L4421A-02

S E R V I C E N O T E

L4421A 40-Channel Armature Multiplexer

Instrument cannot operate in 400 Hz

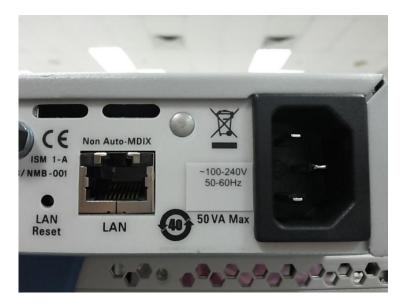
It has been found that the instruments with affected serial numbers listed above have incorrect information printed on the power rating label. The instrument does NOT support 400 Hz operation at 100-127V.

Order a L4421-84303 L44xxA Power Rating Label and apply it over the existing power rating information on the instrument. After applying the L4421-84303 label, it should look similar to the picture below.
